HISTORIC AND DESIGN REVIEW COMMISSION

HDRC CASE NO: 2021-026
COMMON NAME: Unaddressed lot to the immediate south of 334 Burleson, on N Mesquite
ADDRESS: 334 BURLESON ST
LEGAL DESCRIPTION: NCB 519 BLK 24 LOT E 42 FT OF N 134.09 FT OF 8
ZONING: IDZ-1, H
CITY COUNCIL DIST.: 2
DISTRICT: Dignowity Hill Historic District
APPLICANT: cesar sosa/5 ELEMENTS INTERNATIONAL LLC
OWNER: Ruben Lara/5 ELEMENTS INTERNATIONAL LLC
TYPE OF WORK: Construction of two, 2-story residential structures
APPLICATION RECEIVED: February 04, 2021
60-DAY REVIEW: Not applicable due to City Council Emergency Orders
CASE MANAGER: Edward Hall

Historic and Design Review Commission
Design Review Committee Report

PROJECT NO. S-363
CONSTRUCTION DOCUMENTS
10 SEPTEMBER 2020

1 NORTH ELEVATION
SCALE: 1/4" = 1'-0"

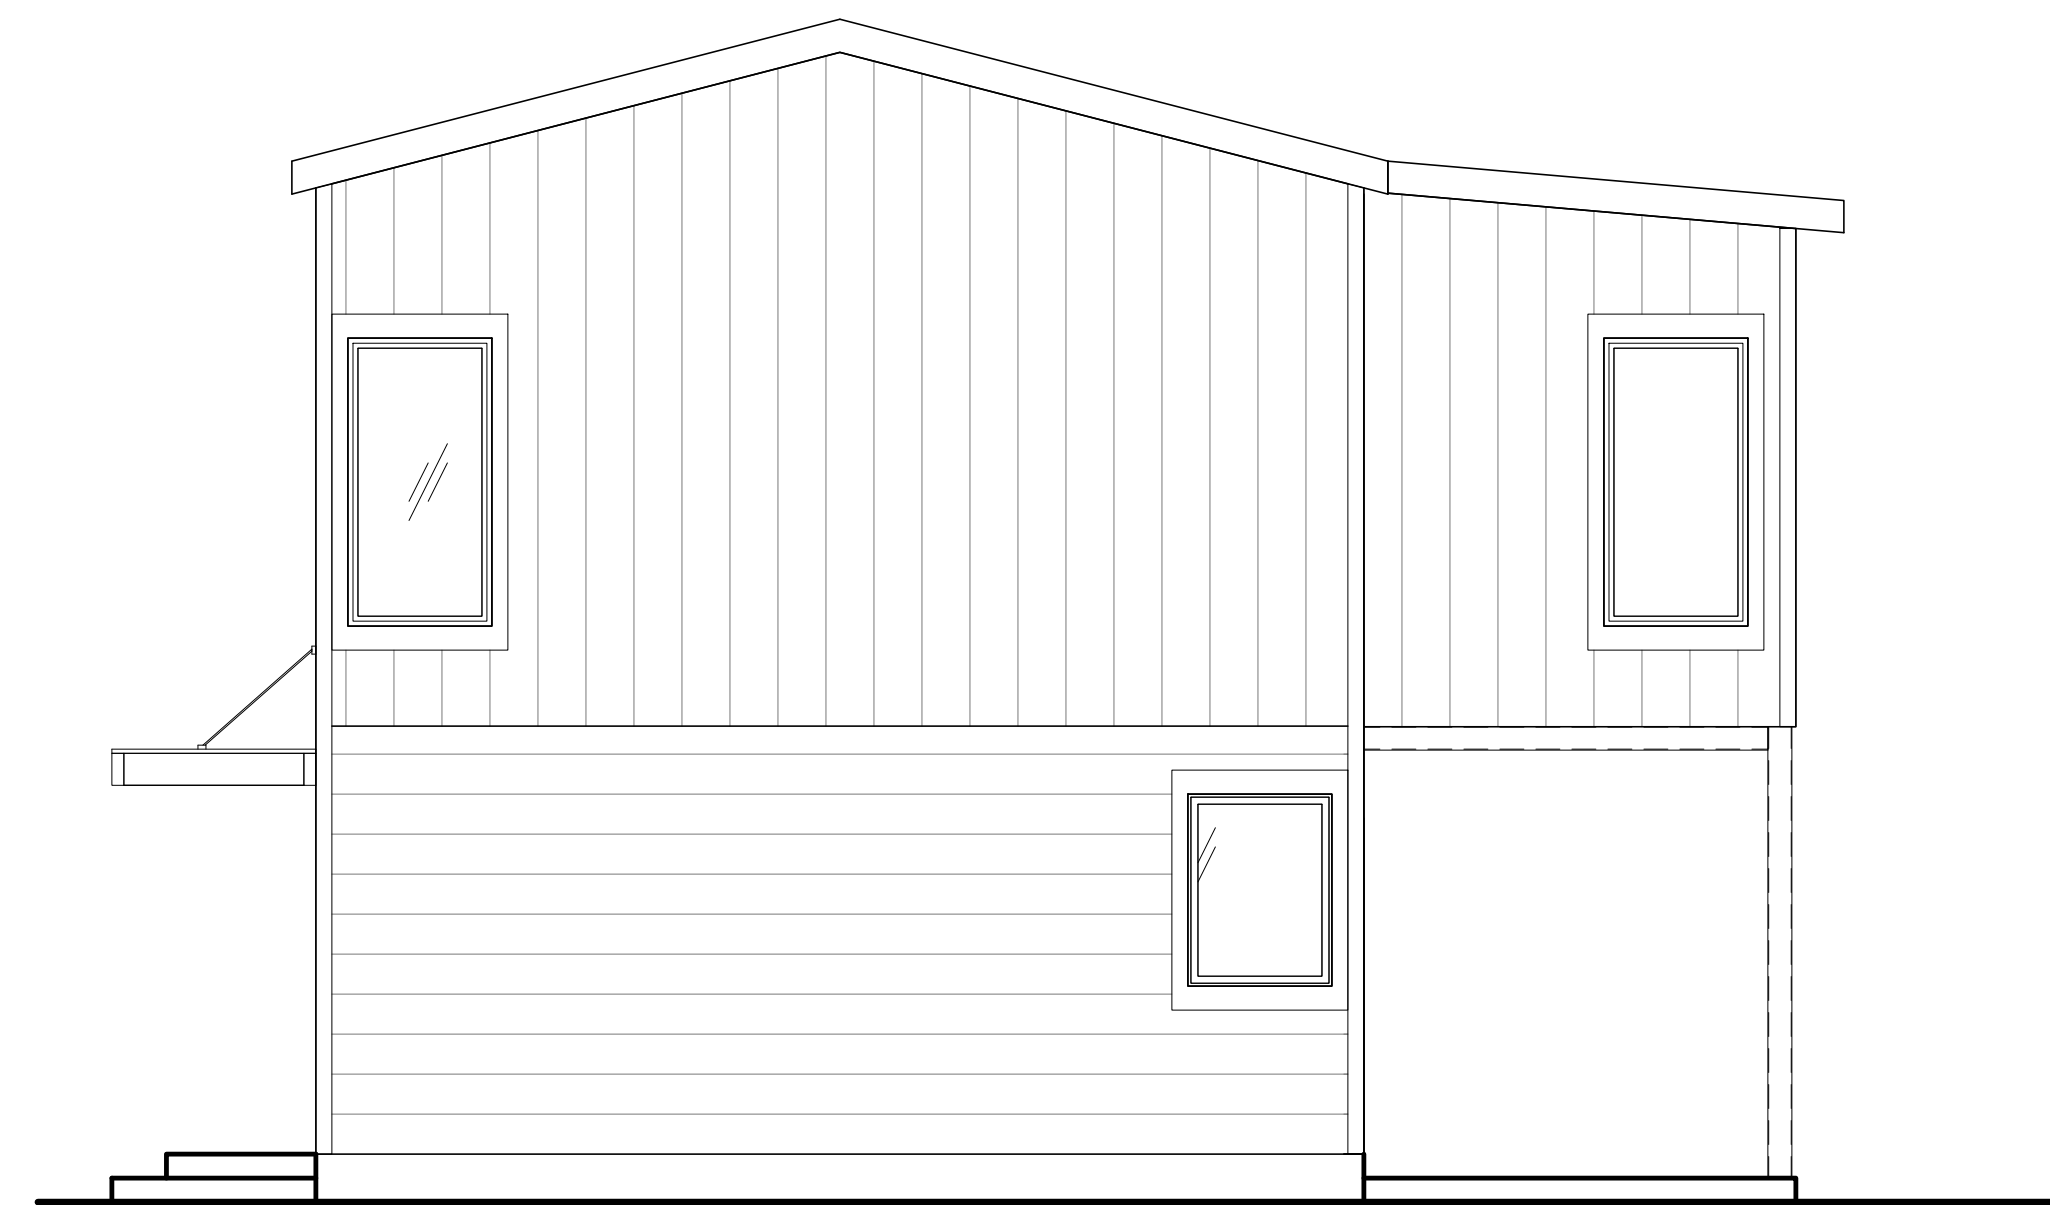
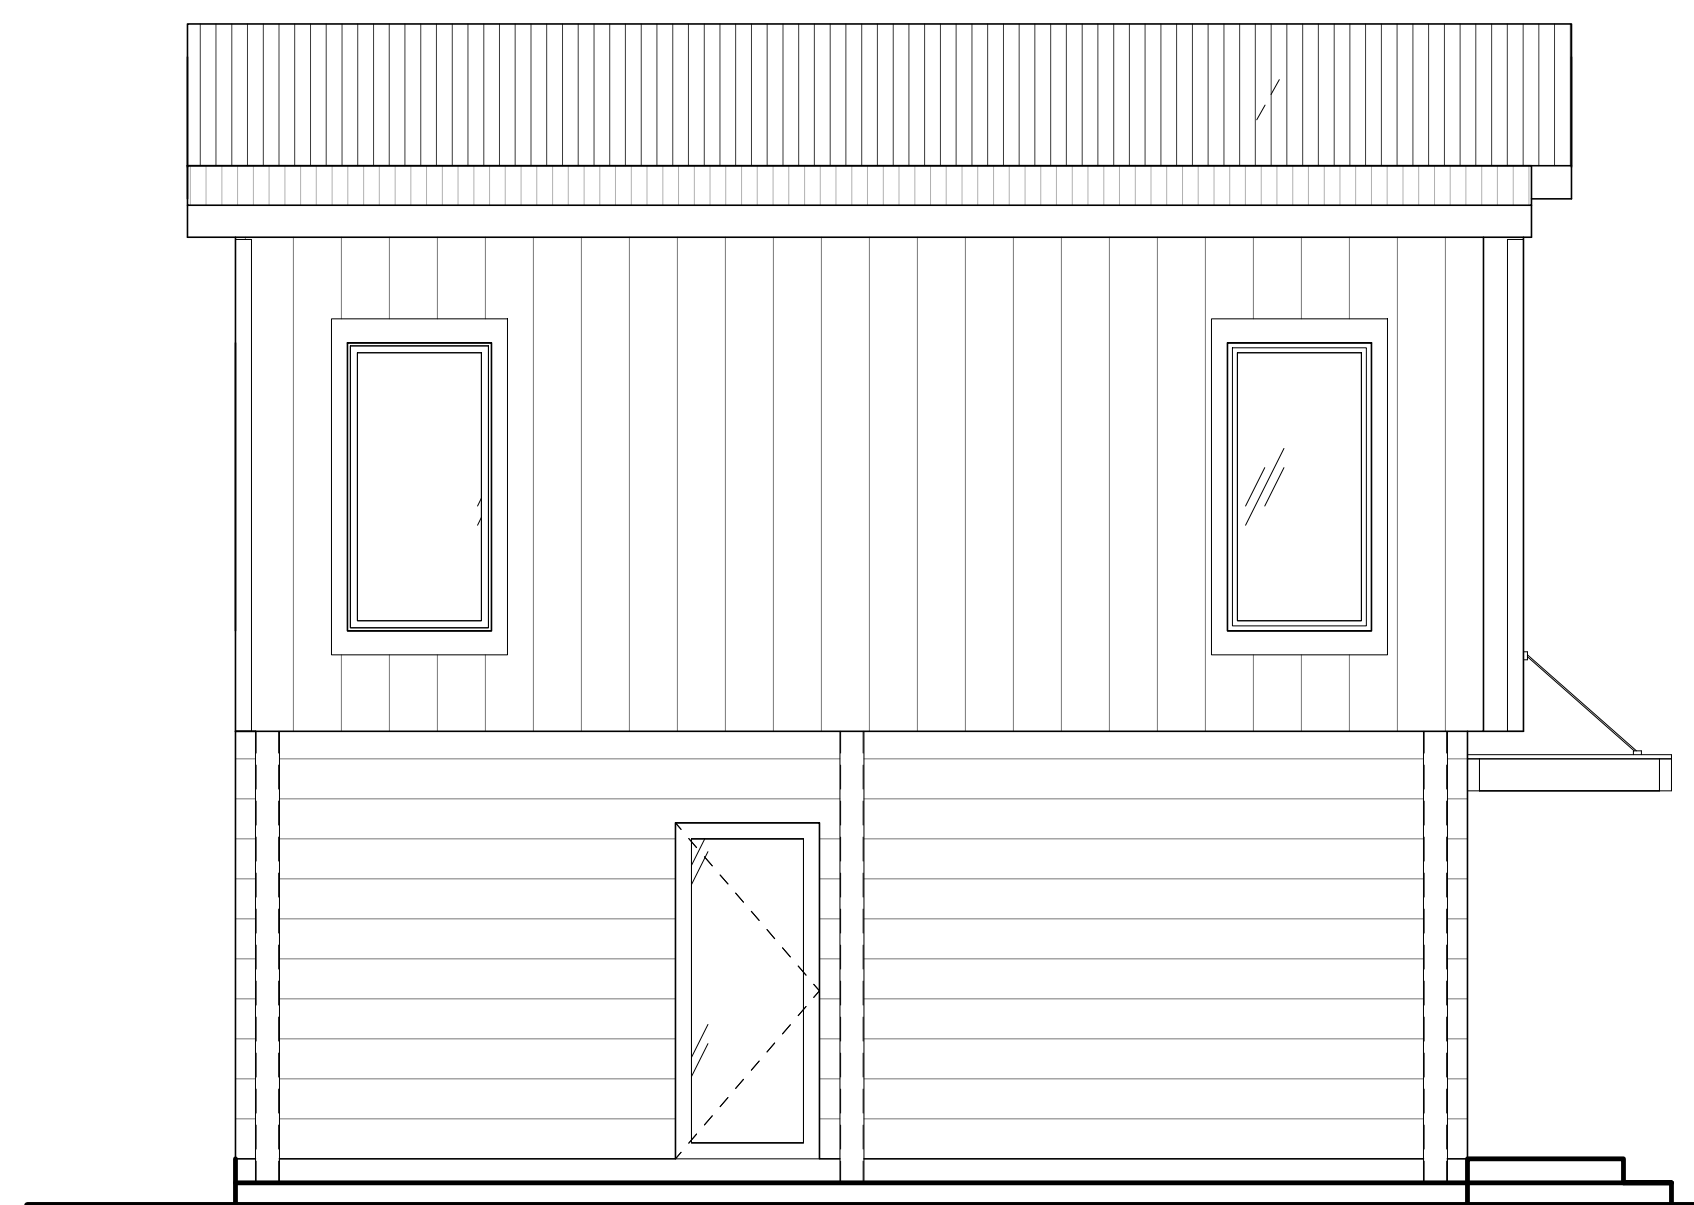
- 2b. SCALE & MASS – Per the Guidelines for New Construction 2.A.i., a height and massing similar to historic structures in the vicinity of the proposed new construction should be used. In residential districts, the height and scale of new construction should not exceed that of the majority of historic buildings by more than one-story. As noted in finding b, this block on N Mesquite features all one story structures. Staff does not find the proposed massing and height to be consistent with the Guidelines.

- 2c. ENTRANCES – According to the Guidelines for New Construction 1.B.i., primary building entrances should be oriented towards the primary street. The applicant has not proposed design elements that present a primary building entrance. Staff finds that architectural elements that are found historically within the district that relate to building entrances should be incorporated into the design, such as porches and porch massing.

- 2d. FOUNDATION & FLOOR HEIGHTS – Per the Guidelines for New Construction 2.A.iii., applicants should align foundation and floor-to-floor heights within one foot of floor-to-floor heights on adjacent historic structures. The applicant has proposed to construct the structure on grade with no visible foundation height. This is not consistent with the Guidelines.

- 2e. ROOF FORMS – The applicant has proposed a front facing gabled roof with a side shed element. Gabled roofs are found historically within the district; however, staff finds that the applicant should continue to develop the proposed roof form to be consistent in pitch and profile as those found historically within the district.

- 2f. WINDOW & DOOR OPENINGS – Per the Guidelines for New Construction 2.C.i., window and door openings with similar proportions of wall to window space as typical with nearby historic facades should be incorporated into new construction. The applicant has proposed window and door openings that are contemporary in profile and size. Staff finds that the proposed window and door openings are not consistent with the Guidelines and should be modified.

- 2i. ARCHITECTURAL DETAILS – The applicant has proposed new construction that features contemporary forms. Generally, the proposed massing, lack of porch massing, window and door openings, materials and façade detailing are not consistent with the Guidelines.

- iii. That the applicant incorporate both entrance massing and architectural entrance elements as noted in finding 2c.
 - iv. That the applicant incorporate foundation and floor heights that are consistent with the Guidelines, as noted in finding 2d.

- v. That the applicant incorporate roof forms that are consistent with the Guidelines as noted in finding 2e.
 - vi. That the applicant incorporate window and door openings that are consistent with the Guidelines as noted in finding 2f.
